AEP:NRC:6055-15  
10 CFR 50.55a

Donald C. Cook Nuclear Plant Units 1 and 2  
INSERVICE TEST PROGRAM – RELIEF REQUESTS REL-002 AND REL-021  
REQUEST FOR ADDITIONAL INFORMATION  
(TAC NOS. MD2498, MD2499, MD0939, MD0940)

INSERVICE TEST PROGRAM – RELIEF REQUESTS REL-002 AND REL-021  
REQUEST FOR ADDITIONAL INFORMATION

Figure 1  
Emergency Core Cooling System – Recirculation Phase

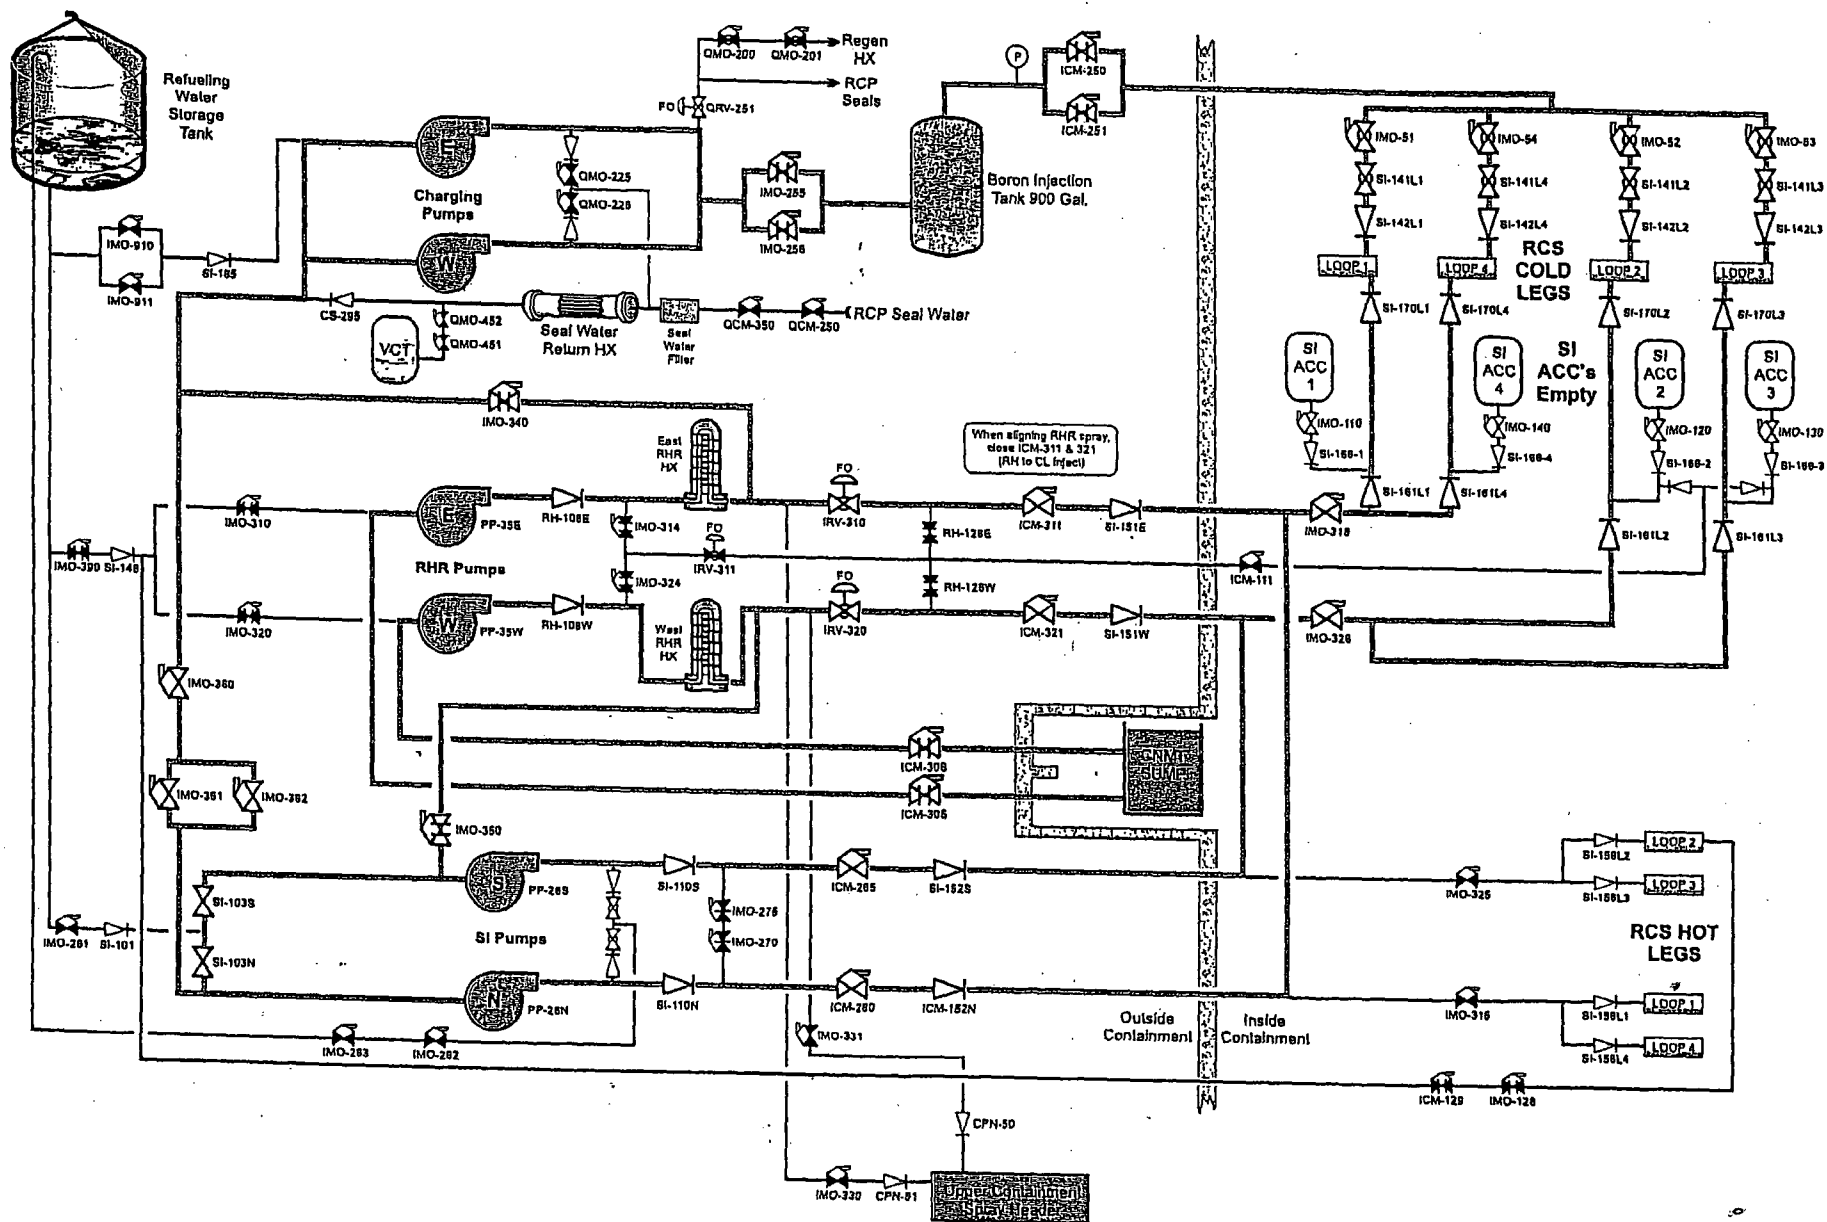
What is/are the specific failure scenario(s) leading to classification of the subject valves as Category A? Describe the rationale for re-categorizing the valves as Category A, including specific postulated failures of the check valve and gate valve pairs.

The proposed alternative is to test the subject valves in the direction opposite the direction in which the leakage function applies using the head of RWST water. What is the expected differential pressure for this test and how does it compare with the accident condition where leakage is a concern? Describe how this test provides assurance that the disc face needed for isolation of accident leakage will fulfill its safety function.

If system configuration allows for accident direction testing of check valves (SI-101 and SI-185) in series with the motor-operated gate valves (IMO-261, IMO-910, IMO-911) that meets Code requirements for Category A leak testing, has consideration been given to using this test path to test MOV (IMO-261, IMO-910, IMO-911) with the associated check valve internals removed? Are these check valves disassembled and inspected on a regular frequency that would allow a window of opportunity to establish accident direction test conditions for the valves for which relief is requested?

I&M has not assumed any specific failures of these MOVs. Rather, leakage past the check valves down stream of these valves has been postulated. This leakage would allow the residual heat removal pump recirculation phase pressure to be applied to the upstream MOV disc seats, and any leakage past the MOV seats would flow back into the RWST. Leakage into the RWST could potentially impact the off-site dose and control room habitability limits. Based on the allowed overall limit for leakage into the RWST, these valves were re-categorized as Category A (valves for which seat leakage is limited to a specific maximum amount).

The differential pressure during the leak testing of the valves is the static head of the RWST, and is estimated to be between 12 and 17 pounds per square inch differential (psid).

These valves are included in I&M's Generic Letter (GL) 89-10 (Reference 4) program and are adjusted to close against the estimated differential pressure that would exist during the transition from the LOCA injection phase to the LOCA recirculation phase. The seat load on the MOVs is specifically designed to ensure that both seats of the flex wedge are fully seated with sufficient pressure to remain leak tight under the postulated system conditions. The IMO-910 and IMO-911 adjustment is based on a calculated differential pressure of 122 psid at a line pressure of 134 pounds per square inch gauge (psig). The IMO-261 adjustment is based on the pressure differential when the RHR pump is operating at minimum flow. Under this condition, the differential pressure is estimated to be 195 psid at a line pressure of 201 psig (Note: This is a conservative value that exceeds the expected conditions).

Although the accident conditions have a higher differential pressure than that used for the leakage measurement test, the leakage measured during the leakage test is corrected to the higher pressure.

It was not considered prudent to disassemble two 8-inch check valves (SI-101, SI-185) every outage solely to facilitate leak testing. The check valves are not disassembled and inspected. Open exercising and leak testing of the check valves confirms their ability to perform their safety functions. Even if this were attempted, leakage past the valve seat(s) could not be measured. The leakage would have to be based on test volume makeup that would include the boundary valves in the identified leakage, which would be less accurate to quantify postulated leakage than the method that is currently being used.
